INDIANA DEPARTMENT OF TRANSPORTATION

AGENDA

March 15, 2018 Standards Committee Meeting

RE: Agenda for the March 15, 2018 Standards Committee Meeting

Figure 51-9A

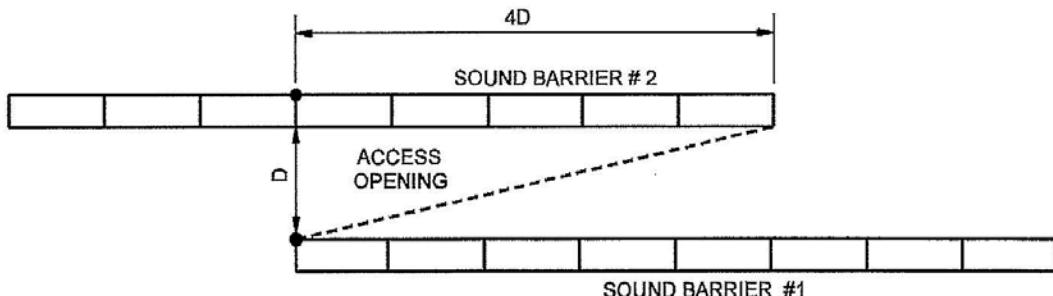
3. Length. To block the roadway noise from the sides, the ends of the barrier should exceed the receiver by four times the distance from the barrier to the receiver; see Figure 51-9A, Sound-Barrier Placement, detail (a).

Figure 51-9B

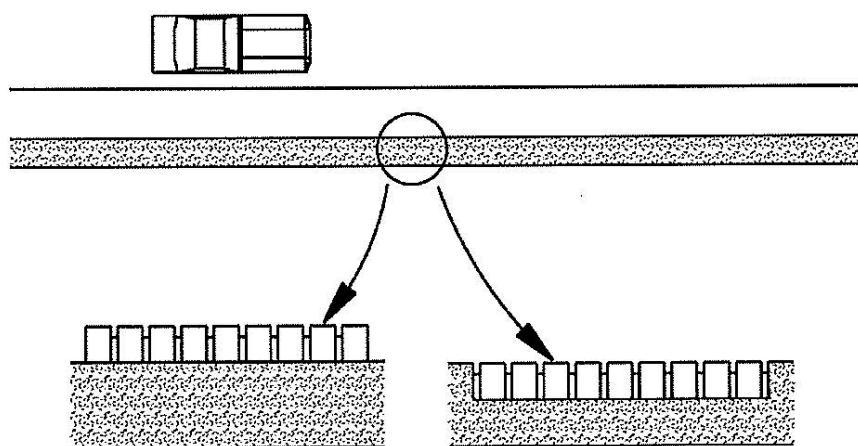
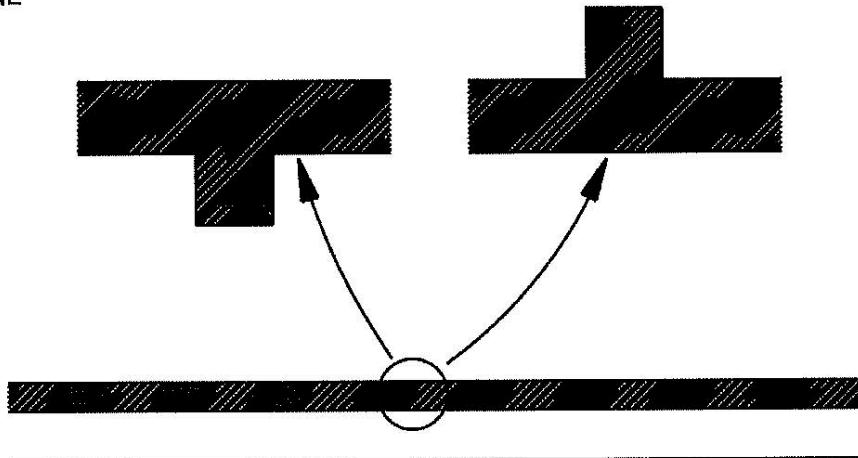
- d. Protrusion. A protrusion may become a safety hazard if it ~~are~~ is struck or is dislodged by a vehicle. Figure [51-9B](#), Sound-Barrier Protrusions, illustrates the preferred practice for placing barrier protrusions and decorative facing.

Figure 51-9C

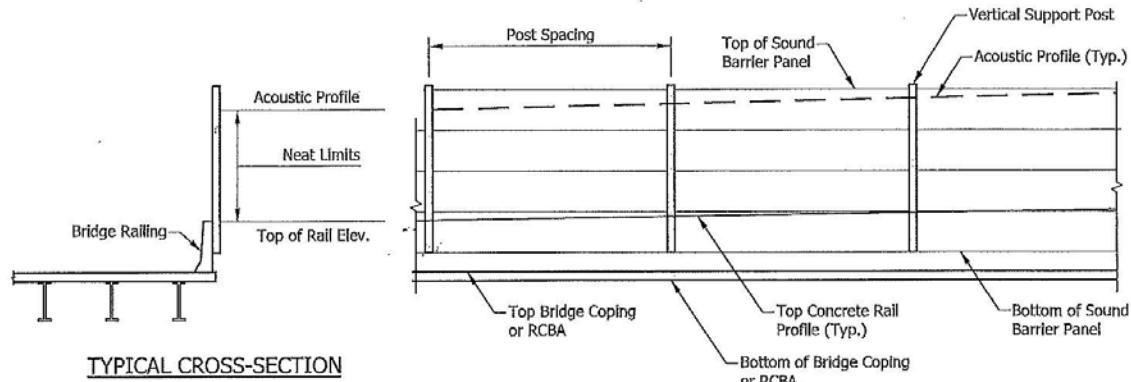
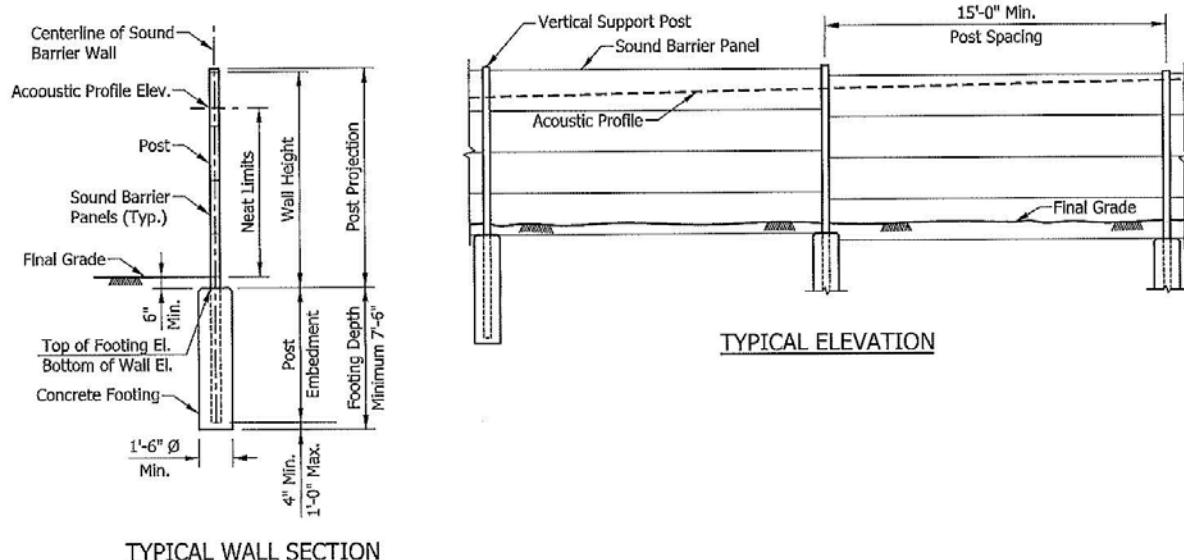
The sound barrier walls attached to the outer face of concrete bridge barrier through vertical supports are termed bridge mounted sound barrier walls, as illustrated by figure 51-9 C. Outside the bridge limits along the roadway, these can be ground mounted on independent support posts and are termed ground mounted sound barrier walls. This illustrated by figure 51-9 D

604-SWCR-01 CURB RAMP DRAWING INDEX AND GENERAL NOTES (WITH MARKUPS)

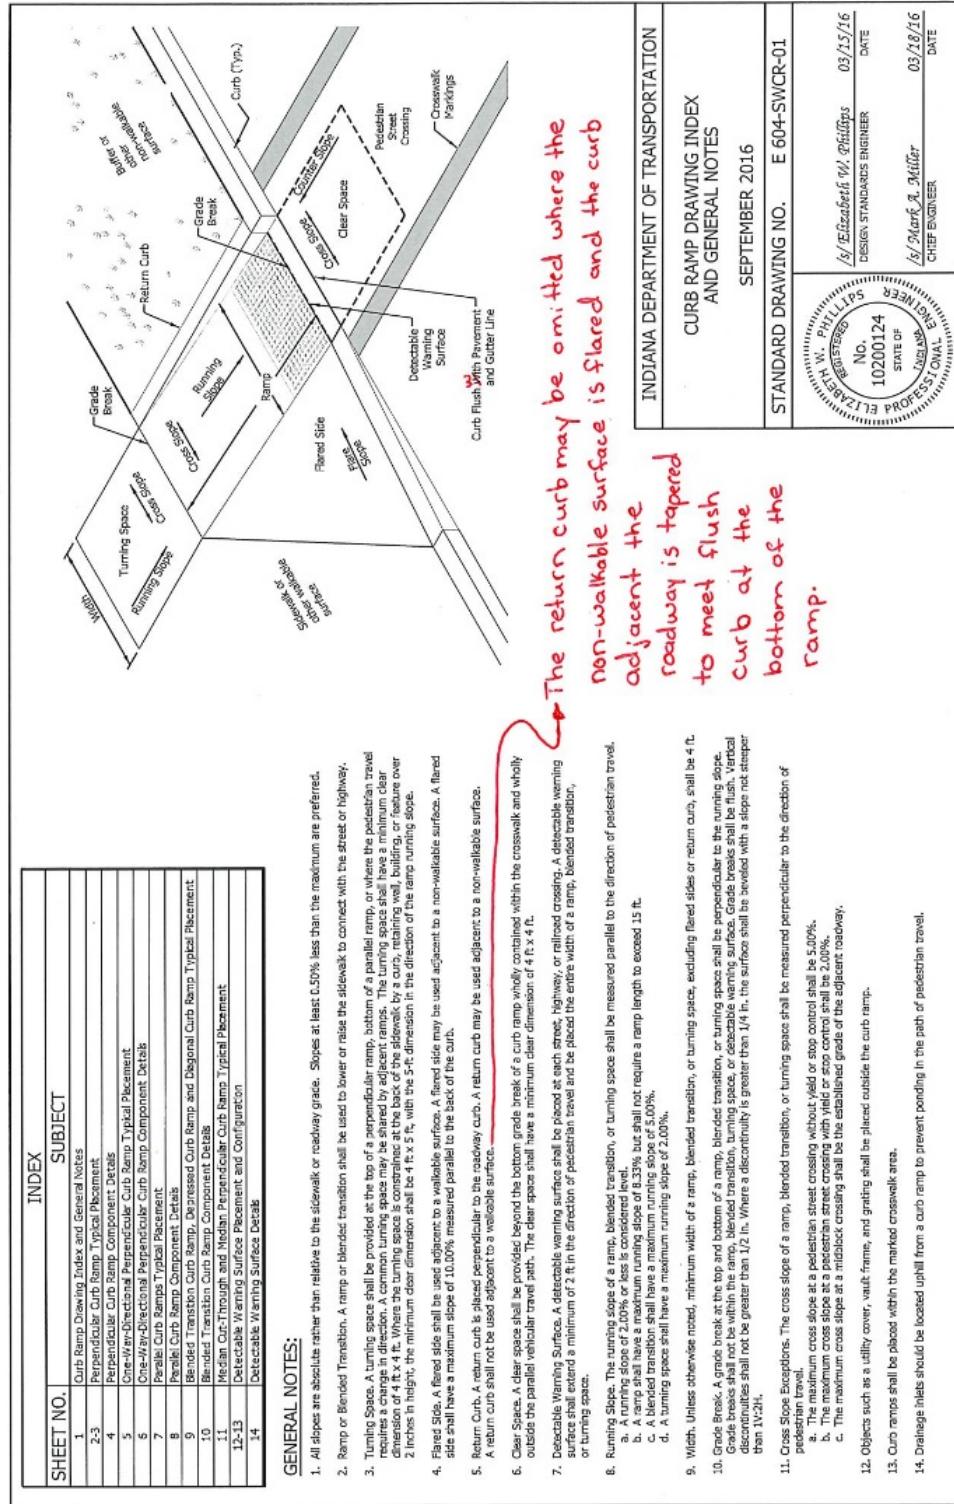
Sheet 1, added to the note for return curb, Note 5.

604-SWCR-04 PERPENDICULAR CURB RAMP COMPONENT DETAILS (WITH MARKUPS)

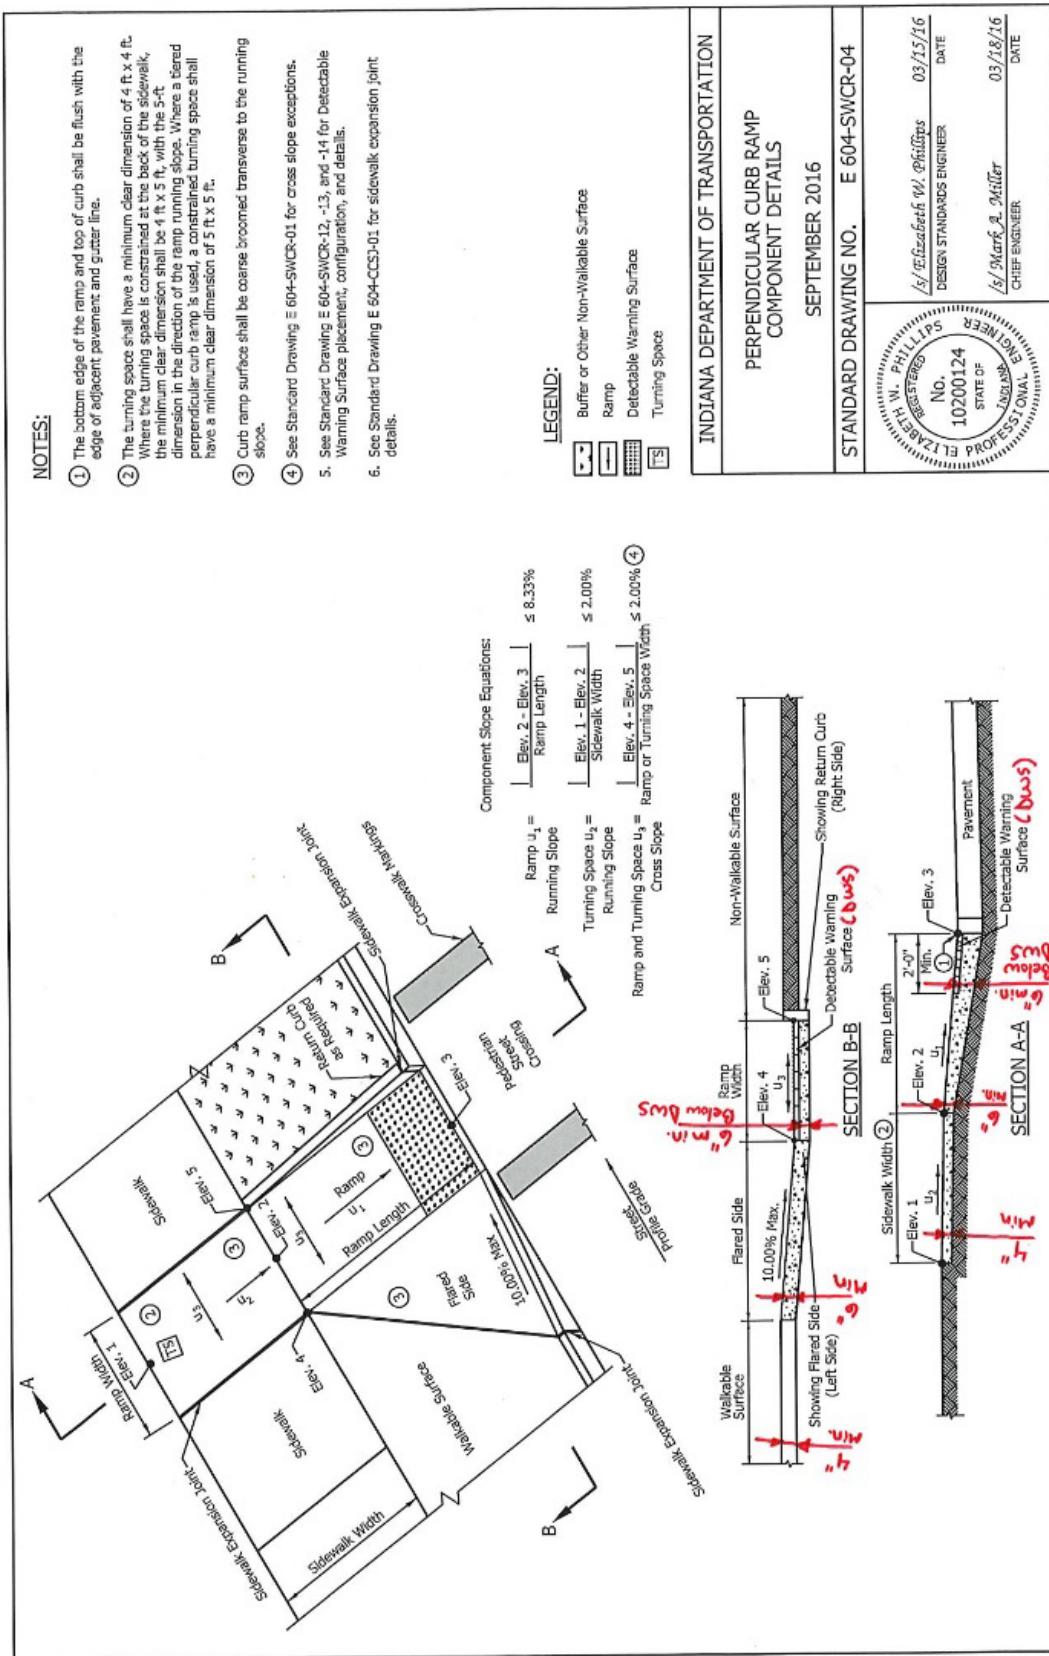
PROPOSED SOLUTION: Revised the Standard Drawing Series 604-SWCR to include the depth of the curb ramp components, sheets 4, 6, 8, 10, and 11.

604-SWCR-12 DETECTABLE WARNING SURFACE PLACEMENT AND CONFIGURATION
(WITH MARKUPS)

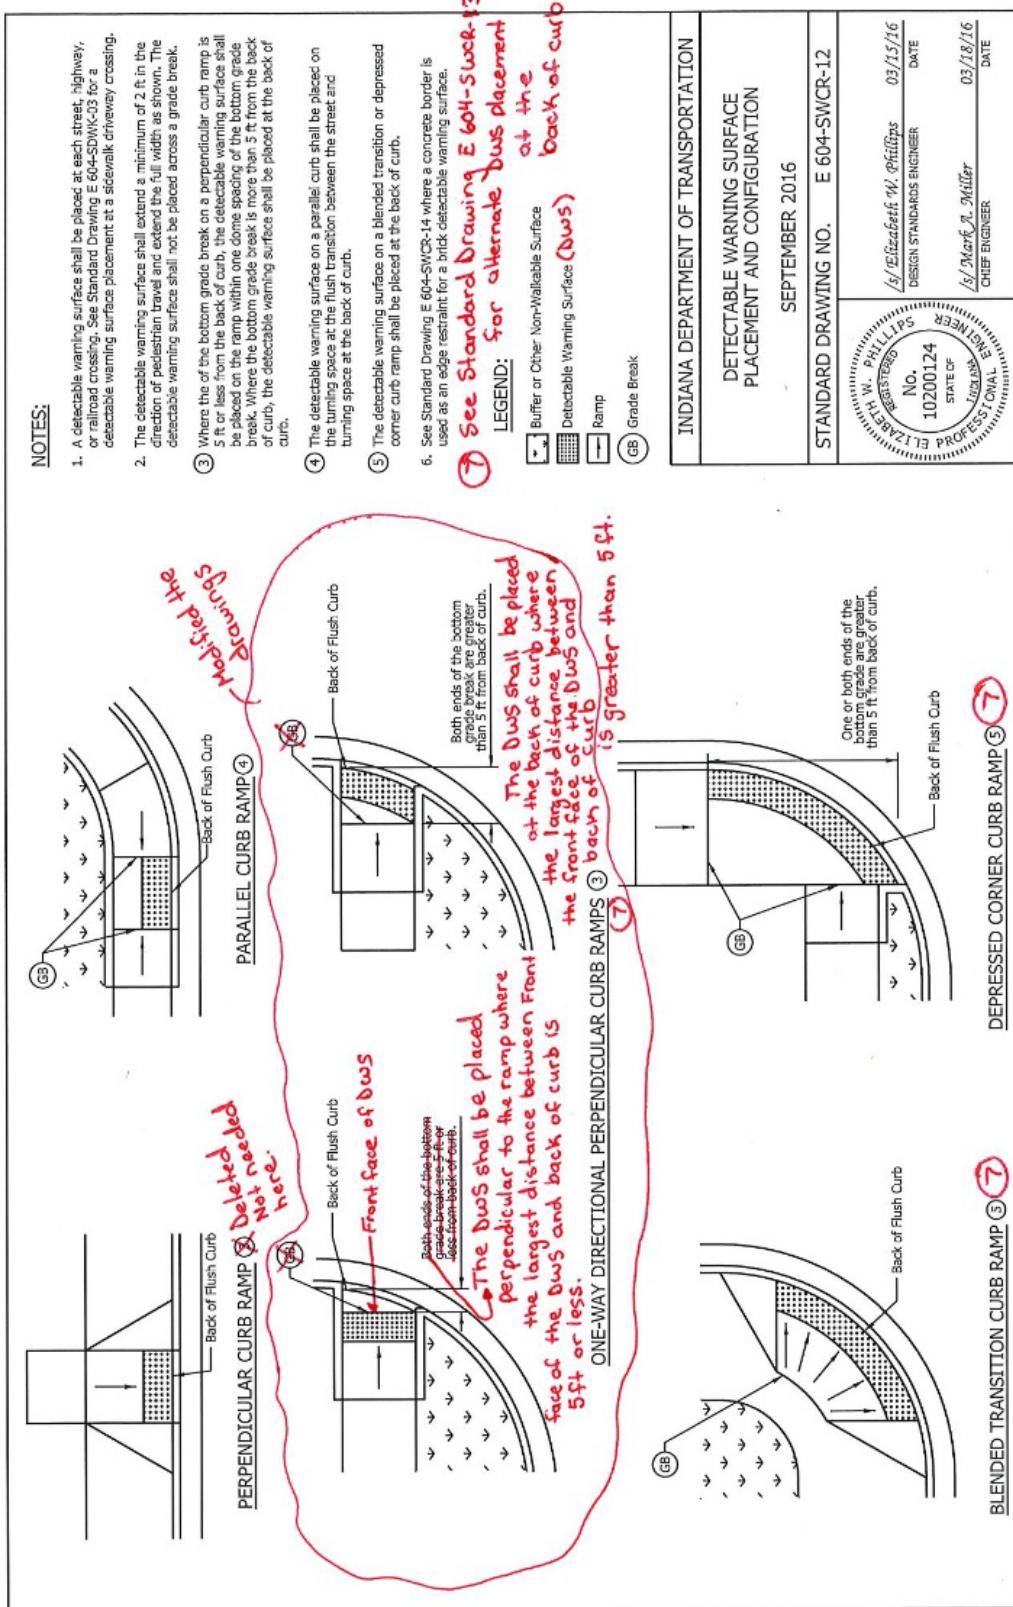
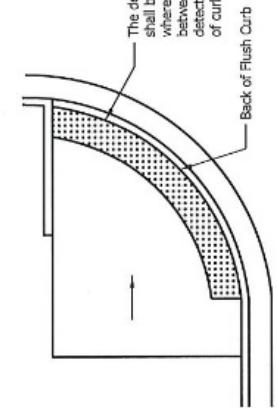
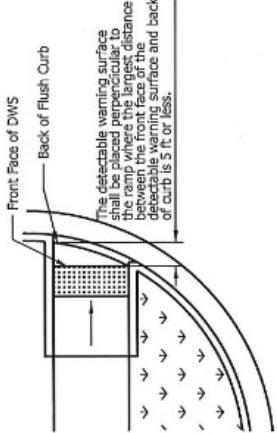
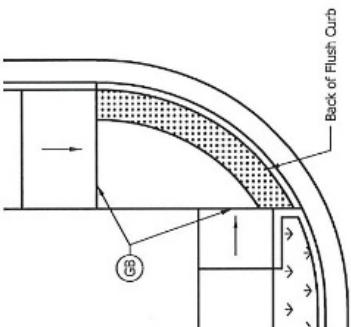
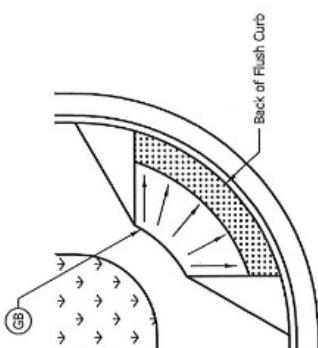
Sheet 12, modified the drawings and notes for the placement of the DWS on a One-Way Directional Perpendicular Curb Ramps. Deleted one note reference to note 3 where it did not belong and added a note 7 to see sheet 13 for alternate placement of a DWS along a radius.

604-SWCR-13 DETECTABLE WARNING SURFACE PLACEMENT AND CONFIGURATION
(WITH MARKUPS)

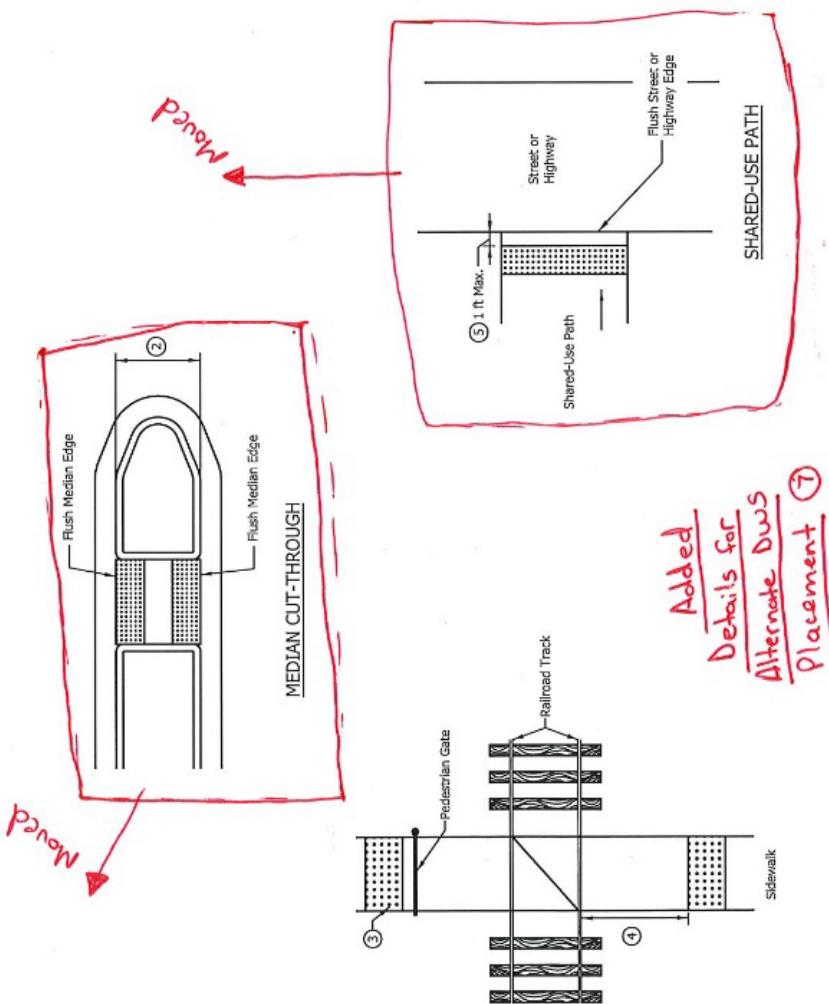
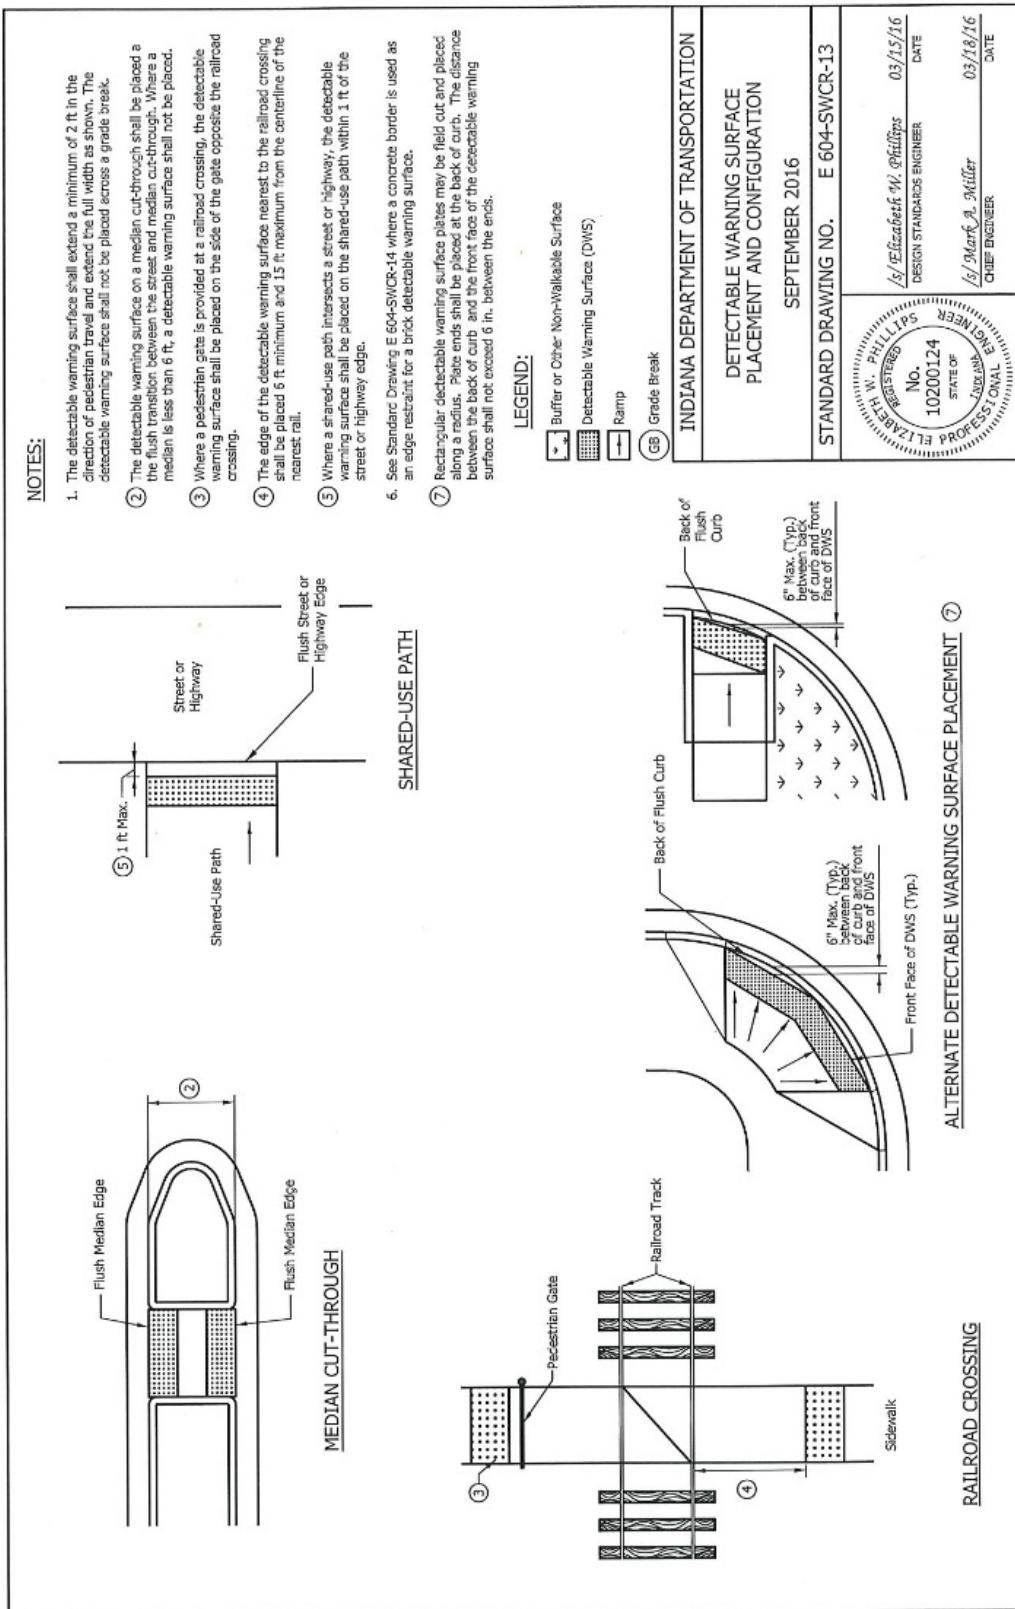
Sheet 13 added a drawing and note for an alternate placement of DWS along a radius.

⑦ Rectangular Dws's plates maybe field cut and placed along a radius. Plate ends shall be placed at the back of curb. The distance between the back of curb and the front face of the dws shall not exceed 6 in. between the ends.
